Attachment A  
Section 92 Response,  
parts 1, 2, 3

**Te Tupu Ngātahi**  
Supporting Growth  
PO Box 105218  
Auckland 1143

## Attachment A: Section 92 response

Table 1: Proposed Flood Hazard Condition – changes since lodgement and rationale

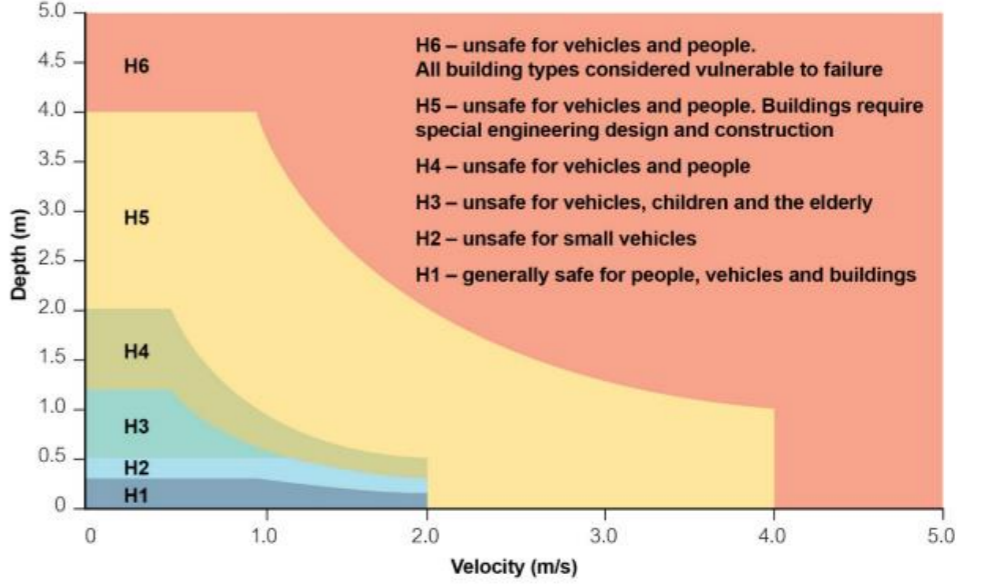
Condition as lodged Sept 2023 (Appendix B, condition 10)	Proposed change to condition	Rationale for change from conditions as lodged
(a) The Project shall be designed to achieve the following flood risk outcomes:	The Project shall be designed to achieve the following flood risk outcomes:	N/A
<ul style="list-style-type: none"> <li>i. no increase in flood levels in a 1% AEP event for existing authorised habitable floors that are already subject to flooding or have a freeboard less than 150mm;</li> </ul>	<ul style="list-style-type: none"> <li>no increase in flood levels in a 1% AEP event for existing authorised habitable floors that are already subject to flooding or have a freeboard less than <del>150mm</del>500mm;</li> </ul>	<p>A site assessment was carried out to estimate the amount of freeboard at buildings that might be affected by flooding close to the proposed NoR boundary (refer Section 4 and the maps in Appendix 1 of the Supplementary Flood Hazard Assessment). When the freeboard was estimated, the majority of those existing floors assessed were either flooded or within 150mm of flooding. Changing to 500mm had a minor increase in the number of floors subject to this condition but the controlling criteria was typically the building with freeboard less than 150mm.</p> <p>The new criteria also provides better protection for relatively new buildings that may be constructed prior to lodgement of the OPW– which is relevant to NoRs near flooding within the Future Urban Zone.</p> <p>Increasing freeboard to 500mm for these types of buildings aligns with freeboard standards in the AC Stormwater Code of Practice for new builds.</p> <p>It is not intended to protect all future buildings – those constructed after the OPW are lodged are expected to set appropriate freeboard above the Post project flood level.</p>

<ul style="list-style-type: none"> <li>ii. no more than a 10% reduction in freeboard in a 1% AEP event for existing authorised habitable floors with a freeboard over 150mm;</li> </ul>	<ul style="list-style-type: none"> <li><del>no more than a 10% reduction in freeboard in a 1% AEP event for existing authorised habitable floors to maintain a minimum with a freeboard of over 150mm;</del></li> </ul>	<p>A percentage freeboard reduction is not needed if a freeboard of 500mm is utilised in criteria i.</p>

Condition as lodged Sept 2023 (Appendix B, condition 10)	Proposed change to condition	Rationale for change from conditions as lodged
<p>iii. no increase in 1% AEP flood levels for existing authorised community, commercial and industrial building floors that are already subject to flooding;</p>	<p>no increase in 1% AEP flood levels for existing authorised community, commercial, industrial and network utility building floors that are already subject to flooding or have a freeboard of less than 300mm;</p>	<p>This criterion has been introduced to address flood effects as these types of building are present in the Project area – such as east of SH1 (NoR4).</p> <p>Increasing the freeboard to 300mm for these types of buildings aligns with freeboard standards in the AC Stormwater Code of Practice for new builds.</p> <p>Given the potential town centre areas in the Future Urban Zone there is potential for more of them to be constructed prior to the lodgement of the OPW. The new criteria provides better protection for relatively new buildings.</p>

The table below sets out the Flood Hazard condition proposed at lodgment, the changes proposed as a result of a review of the condition carried out in December 2023 and our reasons for those changes.
